TO: Khadeja Sarwar, Atwell, LLC
FROM: Cynthia Liston Thye, Planner I
DATE: 9/26/2025
SUBJECT: Parker Pointe, Black Rock Coffee, Site Plan
Review Comments 04

Description: Parker Pointe F1 AMD 1 L4A - Drive Through Coffee Shop	Status: REVISIONS REQD 3+
Type: SITE PLAN	Status Date: 9/10/2025
Subtype: SITE PLAN - NON RESIDENTIAL	Applied: 12/9/2024
Address: 13135 DECLAN DR	Approved:
City, State, Zip: PARKER, CO 80134	Closed:
Project Manager: Cynthia Liston Thye	Expired:
Details: The applicant, Black Rock Coffee, is proposing a Site Plan for a coffee shop with a drive through. The site is located southeast of the intersection of Parker Road and Stroh Road.

BLACK ROCK COFFEE
MODULAR BUILDING

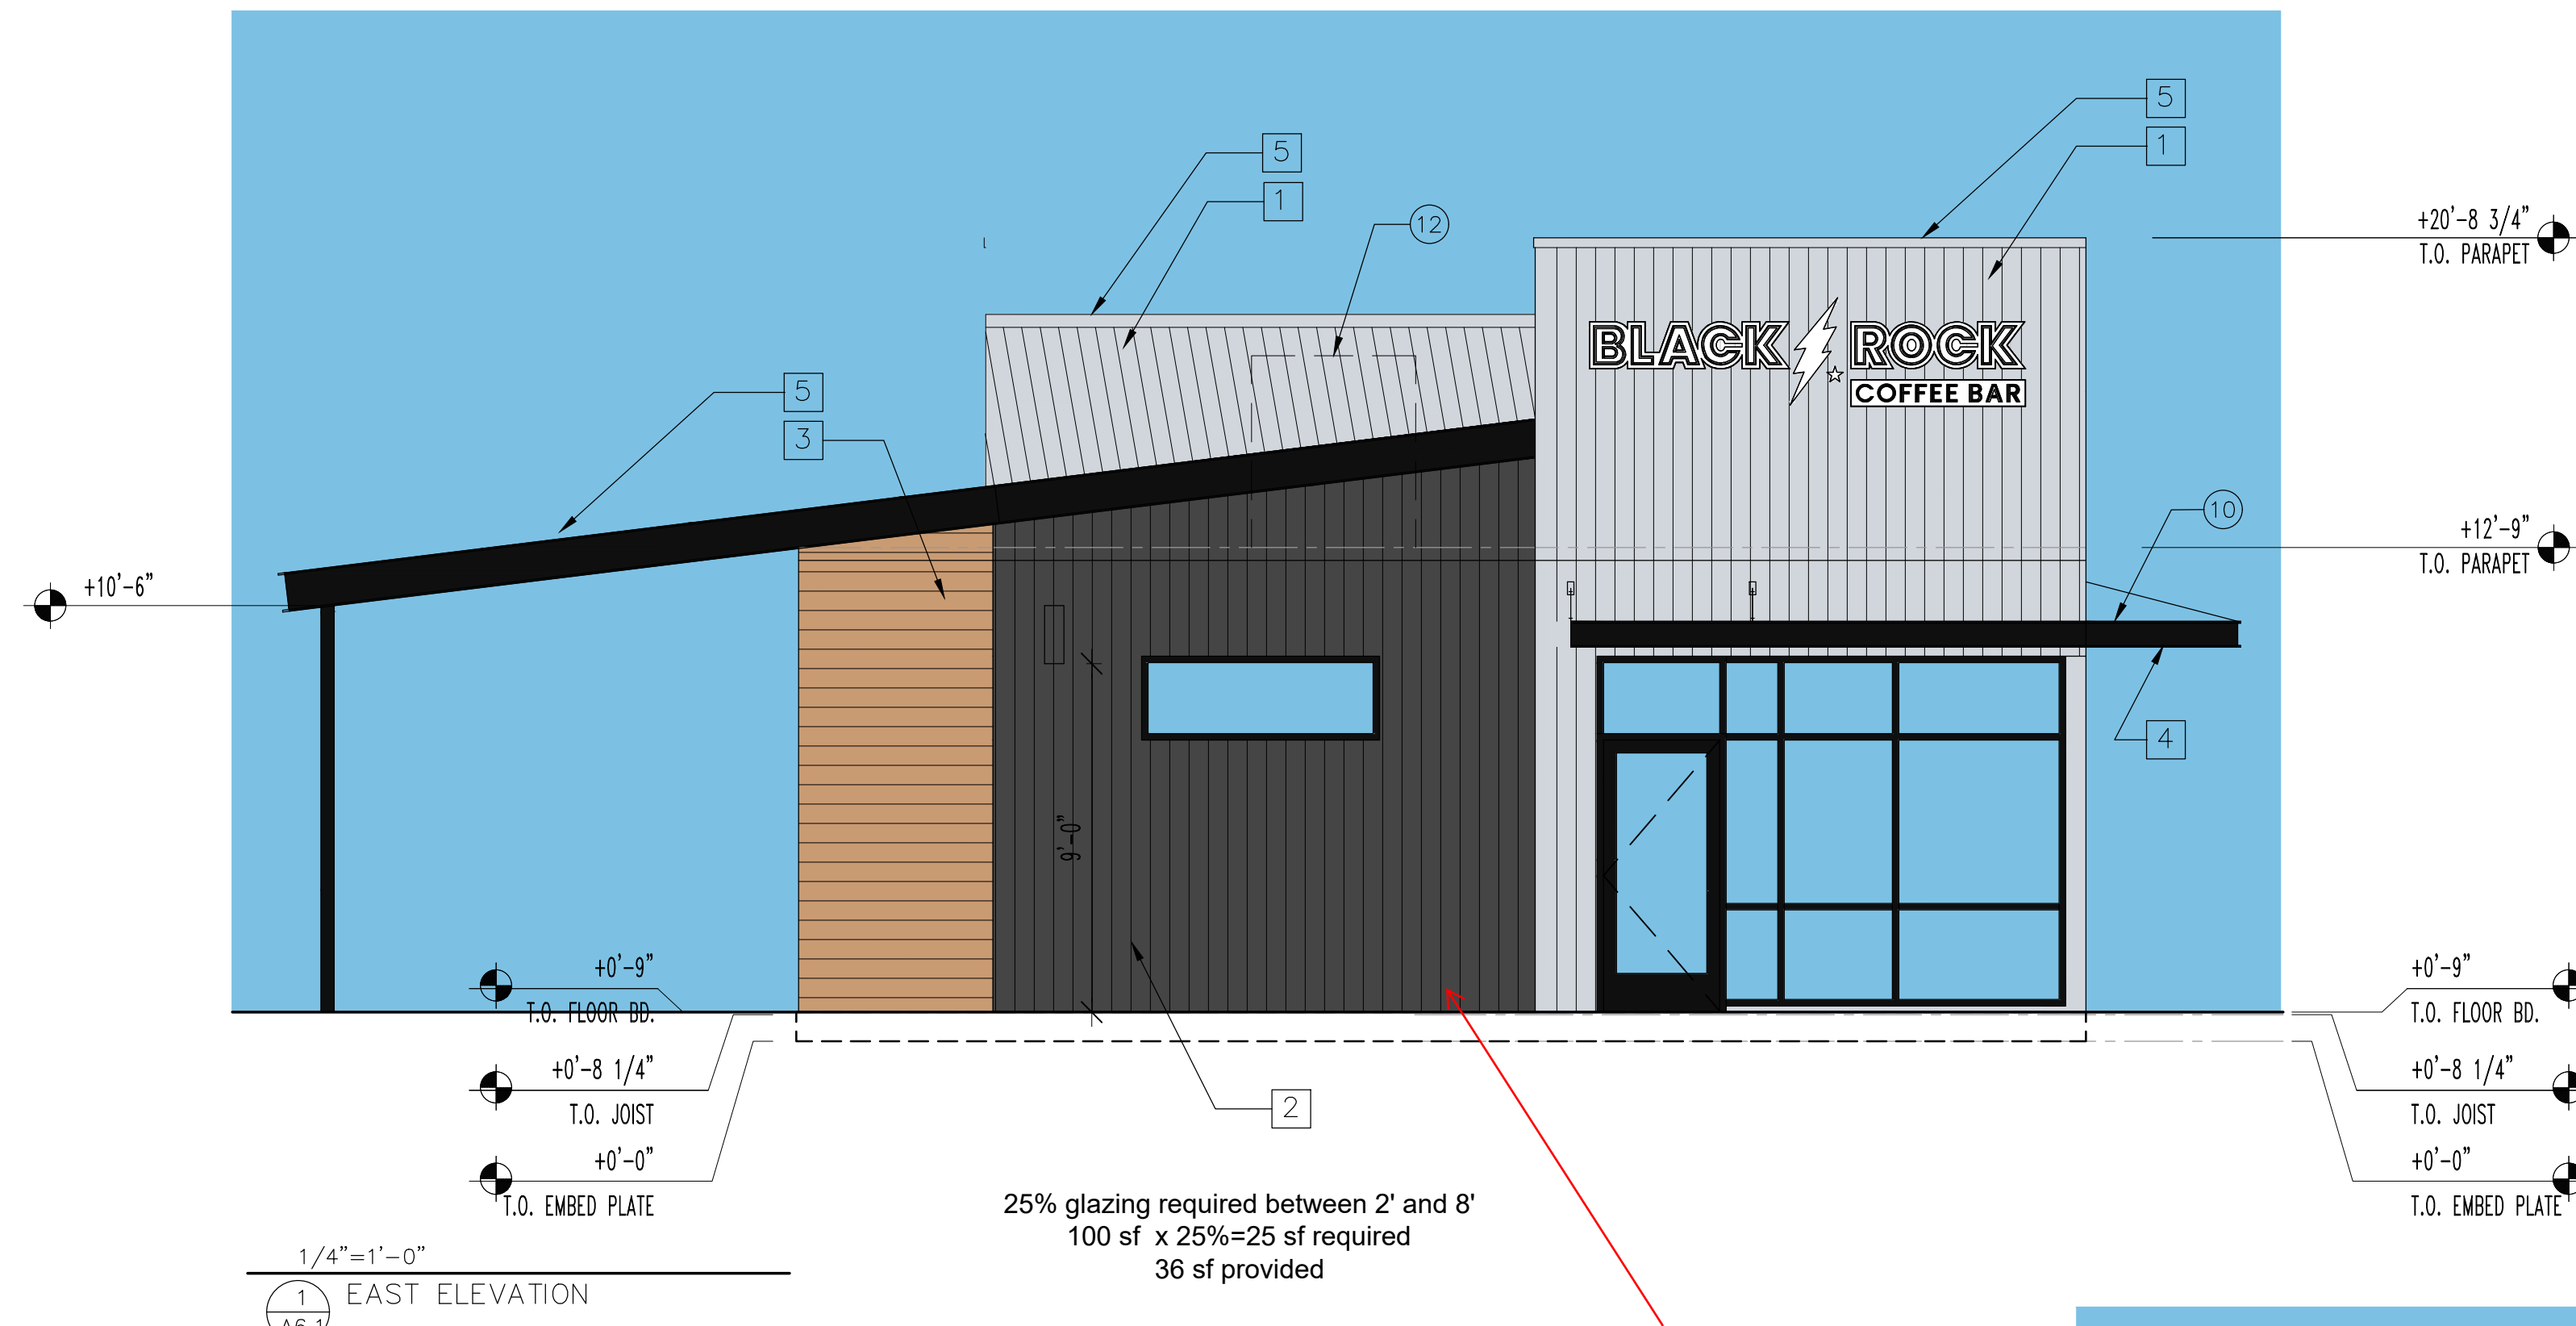
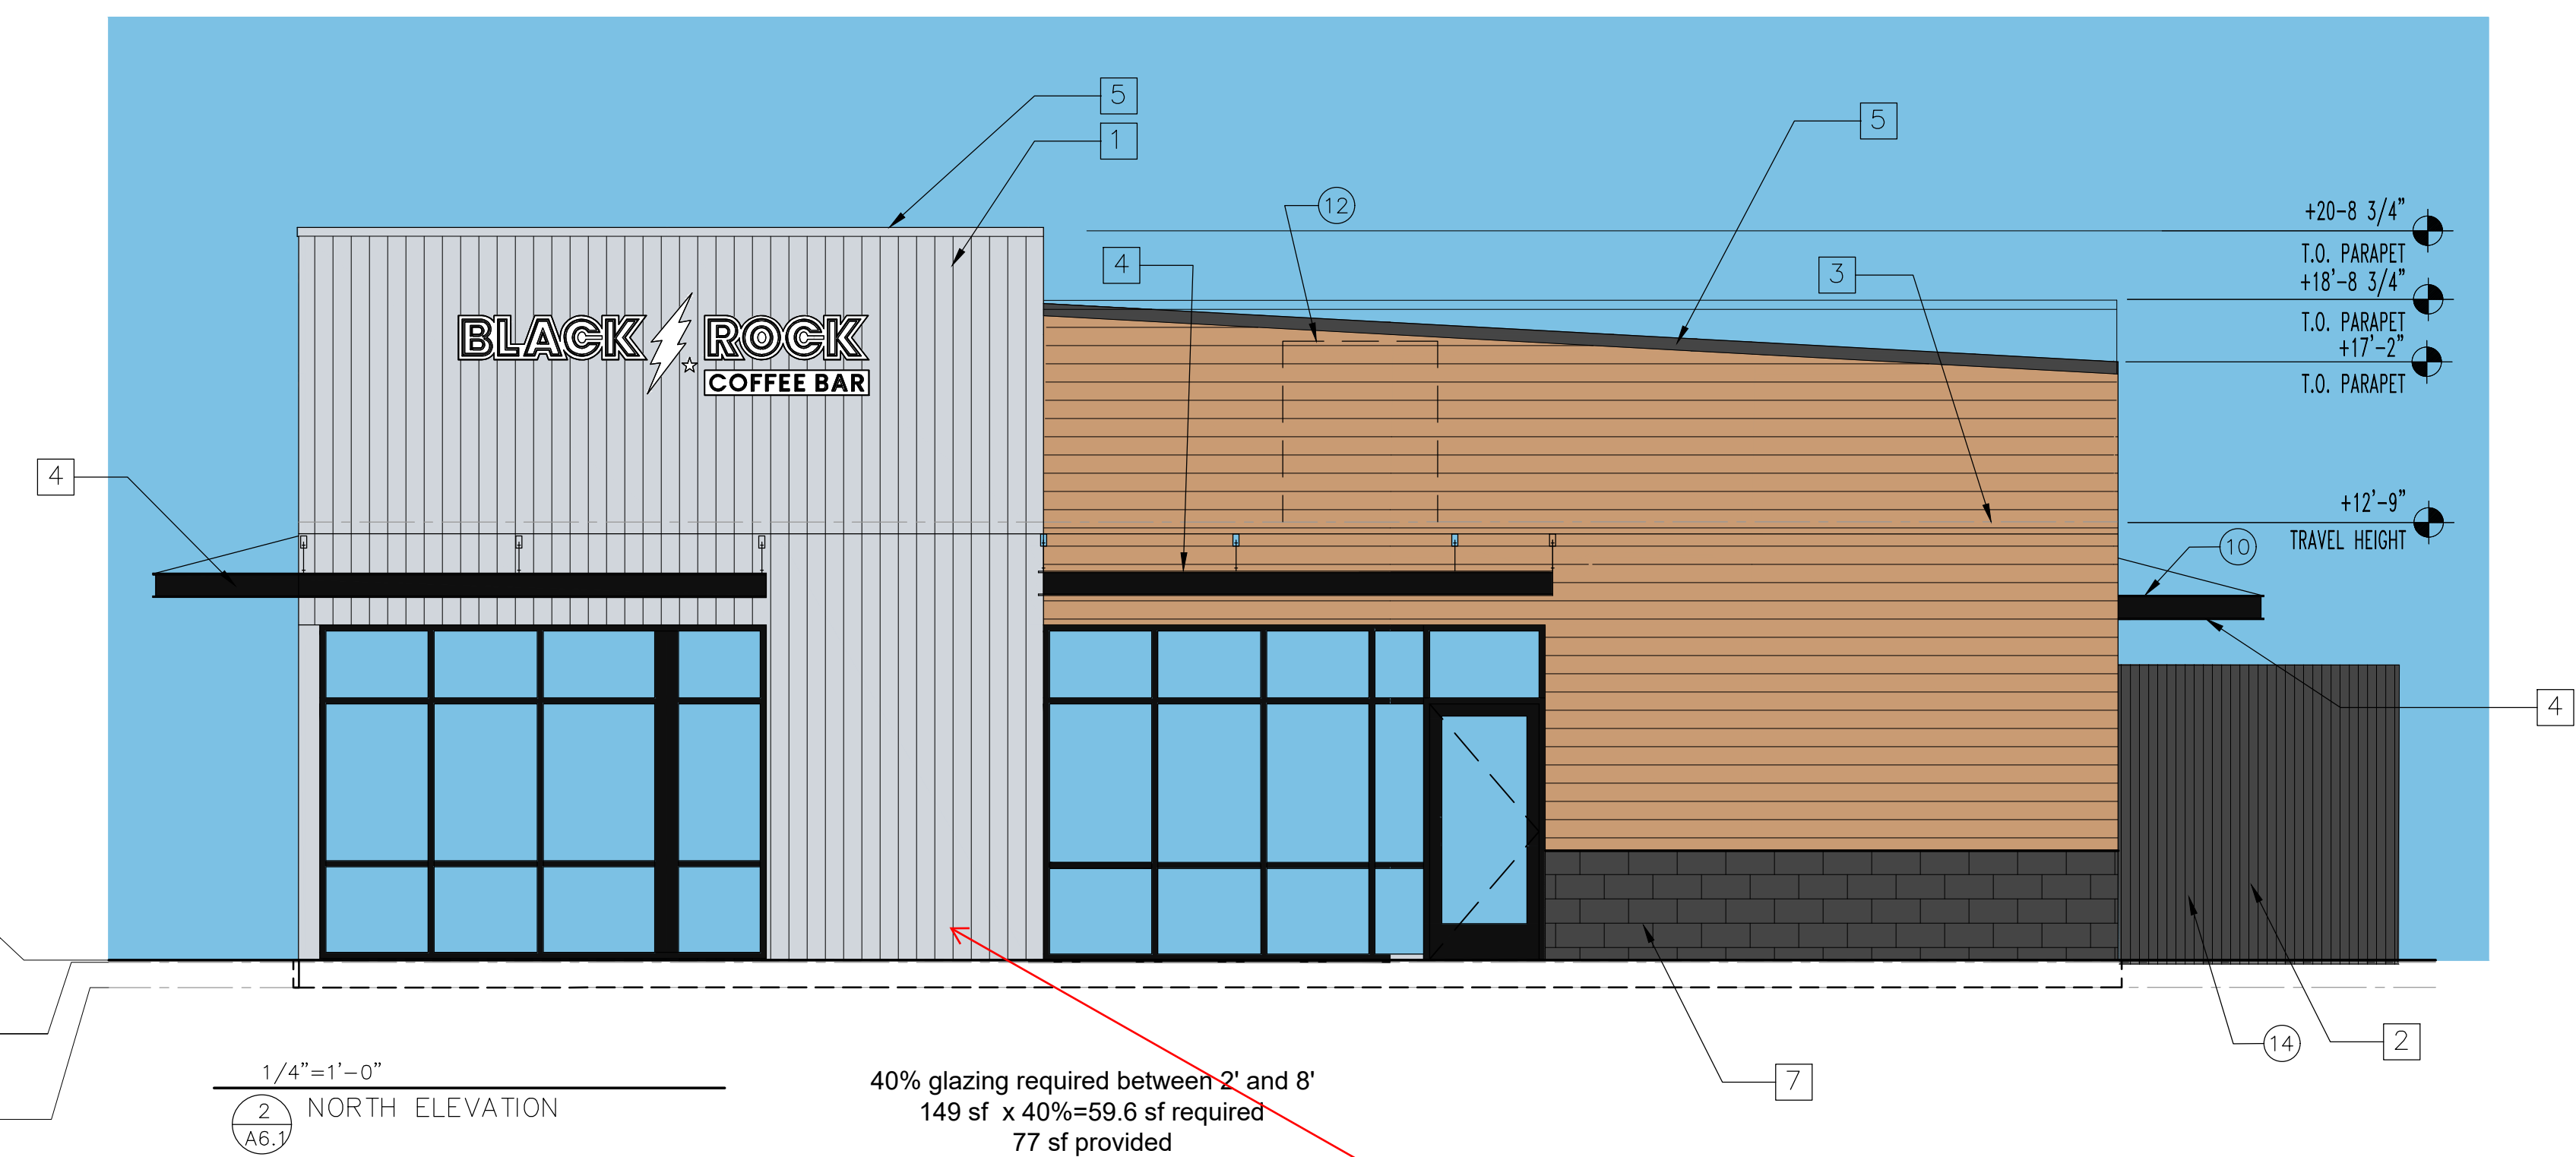
#13 not shown on these elevations
